# UNITED STATES PATENT AND TRADEMARK OFFICE

APPLICATION NO.	FILING DATE	FIRST NAMED INVENTOR	ATTORNEY DOCKET NO.	CONFIRMATION NO.
10/777,943	02/12/2004	Toshiharu Watanabe	44471/297401	5357

**Office Action Summary**

## **DETAILED ACTION**

FIG.2

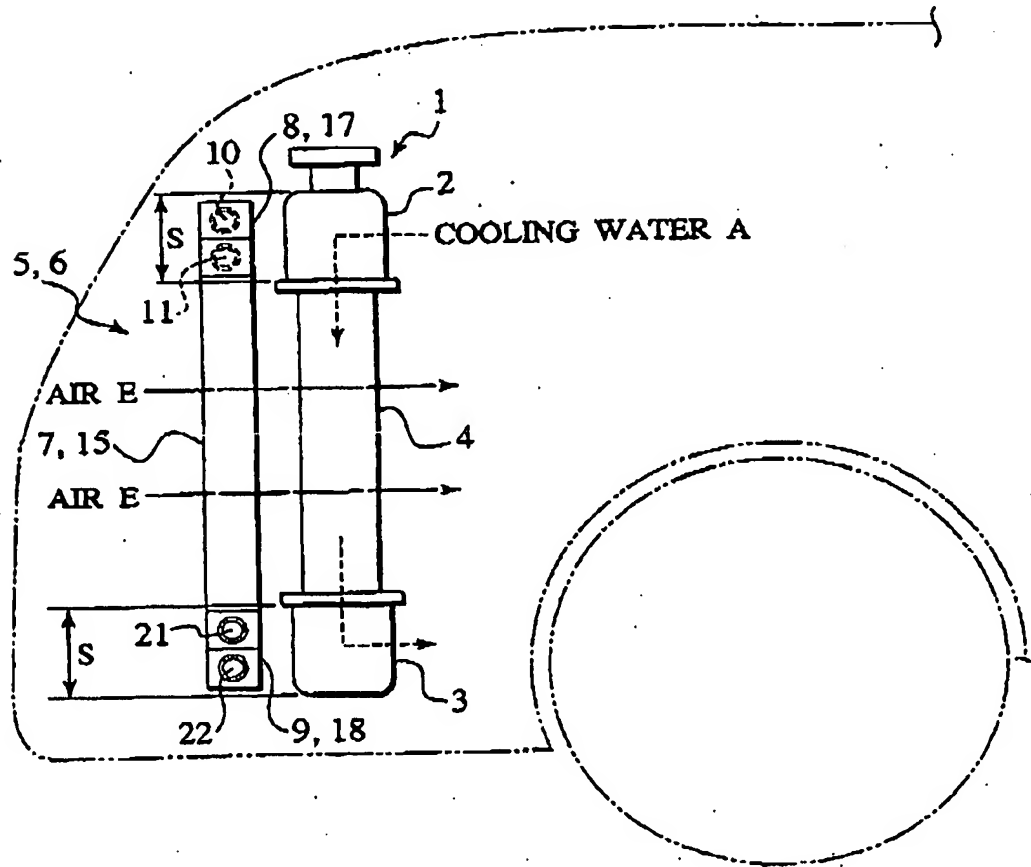
4. Replacement sheets including the required corrections for Figures 1 and 2 were received on December 21, 2006. These drawings are hereby approved.

5. Receipt and entry of the amended abstract filed on March 1, 2007 is hereby acknowledged.
6. The disclosure is objected to because of the following informalities: oil-conducting passages 17 and 18 (as per Figures 1 and 2 as well as the original claims corresponding thereto) which contain NO refrigerant are inappropriately referred to as "refrigerant passages" on pages 13 and 14 of the specification.

Approved.  
 SVC 5-7-07
